# UNITED STATES PATENT AND TRADEMARK OFFICE

APPLICATION NO.	FILING DATE	FIRST NAMED INVENTOR	ATTORNEY DOCKET NO.	CONFIRMATION NO.
10/796,471	03/09/2004	Leilei Zhang	X-1574 US	2282
24309	7590	08/27/2007		
XILINX, INC ATTN: LEGAL DEPARTMENT 2100 LOGIC DR SAN JOSE, CA 95124			EXAMINER DIAZ, JOSE R	
			ART UNIT 2815	PAPER NUMBER
			MAIL DATE 08/27/2007	DELIVERY MODE PAPER

**Office Action Summary**

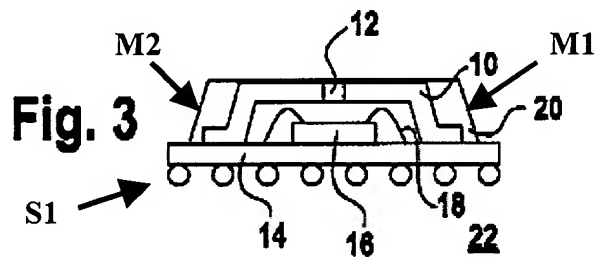
Regarding claim 1, Fishley et al. teaches a package lid for attaching to a package substrate of a packaged semiconductor comprising a sloped wall (11) configured to provide an exposed perimeter portion (40) of the package substrate (14) [see fig. 3, attached below]. With regards to the limitation that the sloped wall is used or configured to provide an exposed perimeter portion when the package lid is disposed on the package substrate, the court has held that a recitation of the intended use of the claimed invention must result in a structural difference between the claimed invention and the prior art in order to patentably distinguish the claimed invention from the prior art. See *In re Pearson* 181 USPQ 641 (CCPA 1974) and *In re Swinehart* 169 USPQ 226 (CCPA 1971). In the instance case, Fishley et al. teaches a sloped wall (11) configured to provide an exposed perimeter portion (40) of the package substrate (14) when the package lid (10) is disposed on the package substrate (14) to allow application of a molding compound (20) on the exposed perimeter portion (40) of the package substrate (14), the molding compound (20) contacting the sloped wall (11) to secure the package lid (10) to the package substrate (14) of the packaged semiconductor (22) [see fig. 3, attached below]. Thus, Fishley et al. anticipates the claimed invention since the prior art structure is capable of performing the claimed intended use.

Regarding claim 19, Fishley et al. further teaches that the package lid (10) is disposed on the package substrate (14) to provide the exposed perimeter portion and further comprising: first molding compound (M1) applied to a first portion of the exposed perimeter portion (portion of substrate 14 covered with first molding compound M1) and contacting the sloped sidewall (11) [see fig. 3, below], and second molding compound (M2) applied to a second portion of the exposed perimeter portion (portion of substrate 14 covered with first molding compound M2) and contacting the sloped sidewall (11), wherein the first portion of the exposed perimeter portion is opposite the second portion of the exposed perimeter portion [see fig. 3, below].

Regarding claim 21, Fishley et al. teaches the package substrate includes a solder ball-grid array (S1) for connecting the packaged semiconductor to a printed circuit assembly [see fig. 3, above].

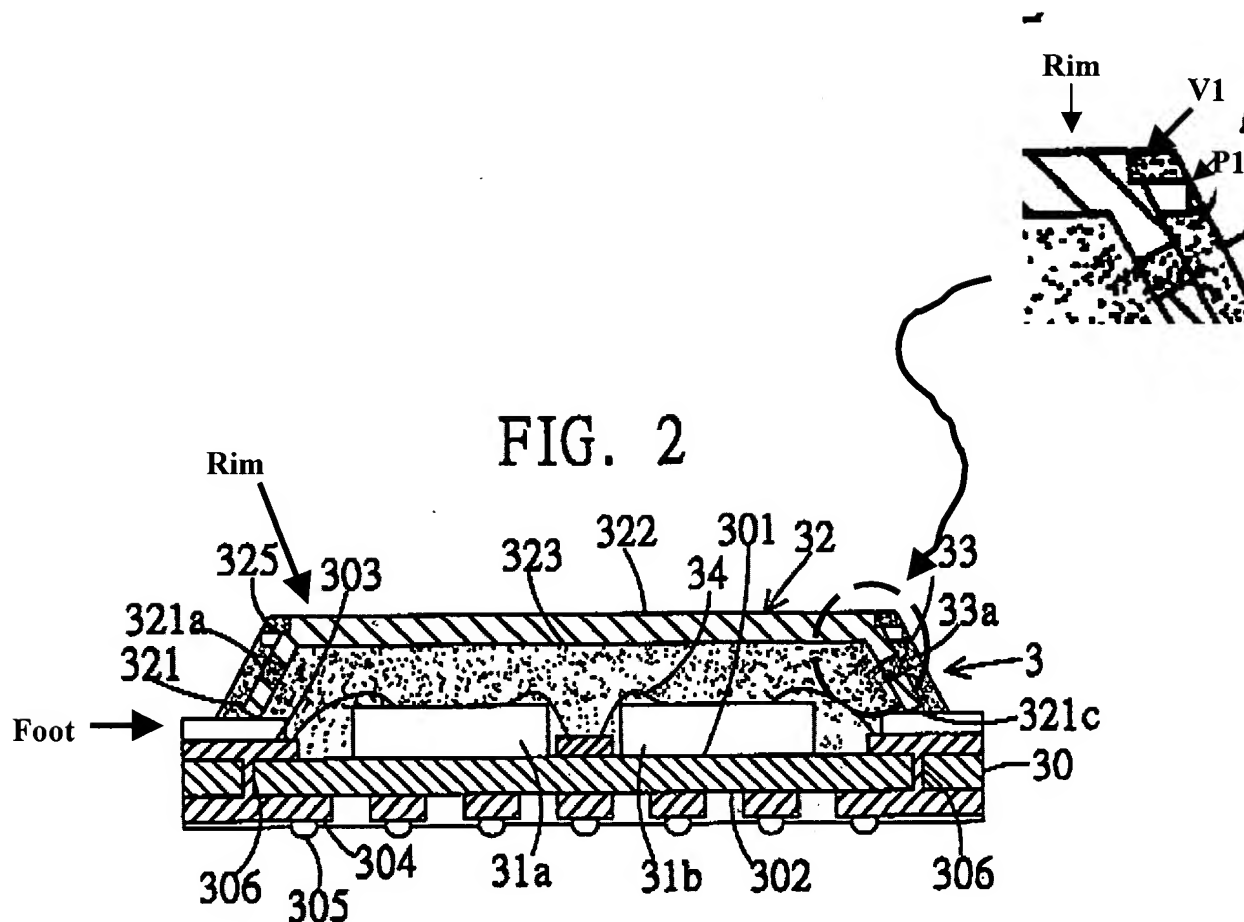
Regarding claim 12, Tang et al. teaches a vertical wall (V1) around a top (322) of the package lid (32) [see fig. 2, attached above].

Regarding claim 13, Tang et al. teaches fiducial marks (consider protrusion P1 or 325) formed in the rim (V1) [see fig. 2, attached above].

Regarding claim 19, Tang et al. teaches a first molding compound (consider the molding compound 33 formed on the sloped wall (321) located on the left side of the structure as shown in figure 2). and a second molding compound (consider the molding compound 33 formed on the sloped wall (321) located on the right side of the structure as shown in figure 2).

Regarding claim 11, Fishley et al. fails to teach a gap in the sloped wall. However, Tang et al. teaches the claimed limitation in figure 2. For instance, Figure 2 shows a gap (321a) in the sloped wall (321) of the package lid (32).

FIG.  
2A

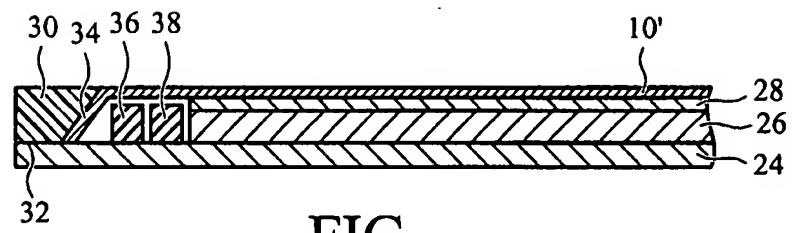
1. The drawings as filed on June 4, 2007 are objected to under 37 CFR 1.83(a) because they fail to show the section line A-A' in figure 2B and the reference sign 35 in figure 2A as described in the amended specification as filed on December 18, 2006. Any structural detail that is essential for a proper understanding of the disclosed invention should be shown in the drawing. MPEP § 608.02(d). Corrected drawing sheets in compliance with 37 CFR 1.121(d) are required in reply to the Office action to avoid abandonment of the application. Any amended replacement drawing sheet should include all of the figures appearing on the immediate prior version of the sheet, even if only one figure is being amended. The figure or figure number of an amended drawing should not be labeled as "amended." If a drawing figure is to be canceled, the appropriate figure must be removed from the replacement sheet, and where necessary, the remaining figures must be renumbered and appropriate changes made to the brief description of the several views of the drawings for consistency. Additional replacement sheets may be necessary to show the renumbering of the remaining figures. Each drawing sheet submitted after the filing date of an application must be labeled in the top margin as either "Replacement Sheet" or "New Sheet" pursuant to 37 CFR 1.121(d). If the changes are not accepted by the examiner, the applicant will be notified and informed of any required corrective action in the next Office action. The objection to the drawings will not be held in abeyance.
